# Product Change Notice (PCN)

**PCN Number:** PCN-0450882R-01

Product(s) Affected: *PJ1-022-SMT-TR*

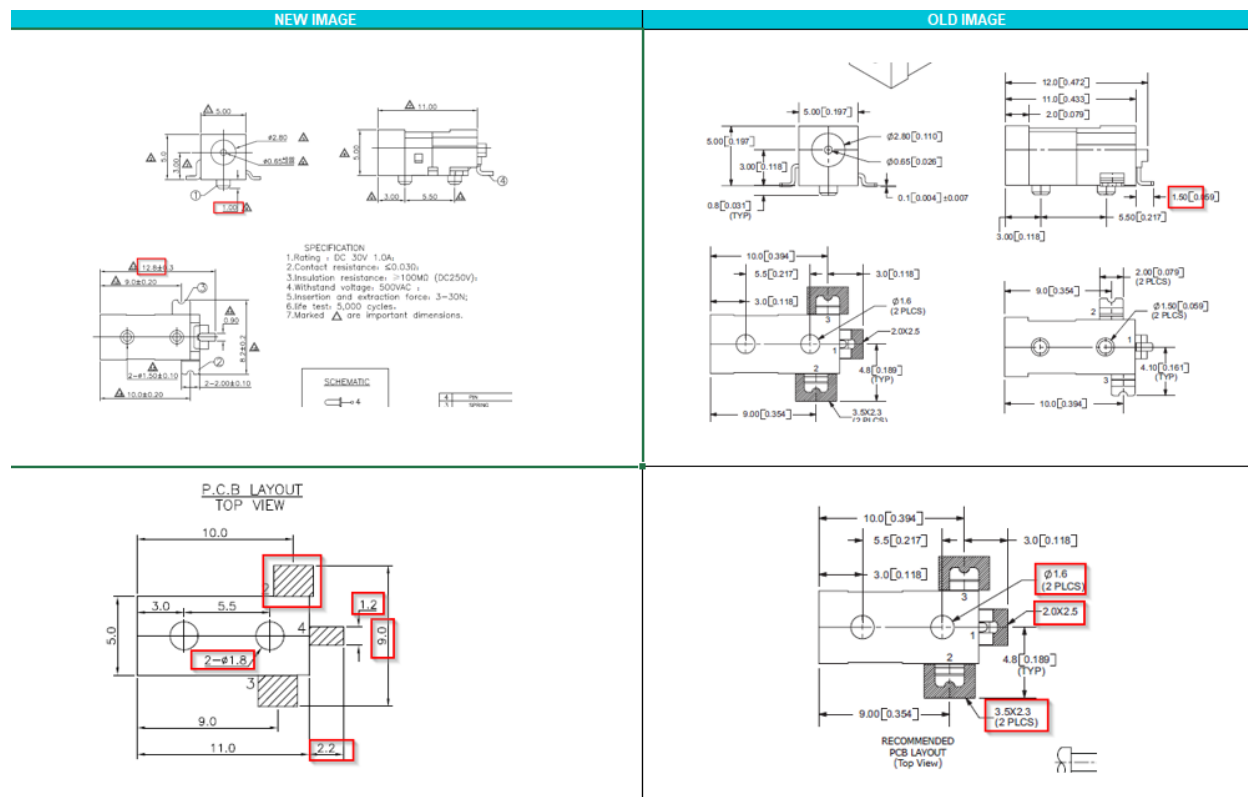
Description of Change: *Minor Housing and footprint differences. Material Change on the housing and terminals. See image Below*

Center Pin: Brass to Bronze  
Terminal 2: Copper Alloy to Brass  
Plastic: PA6T or Equivalent to PA10T
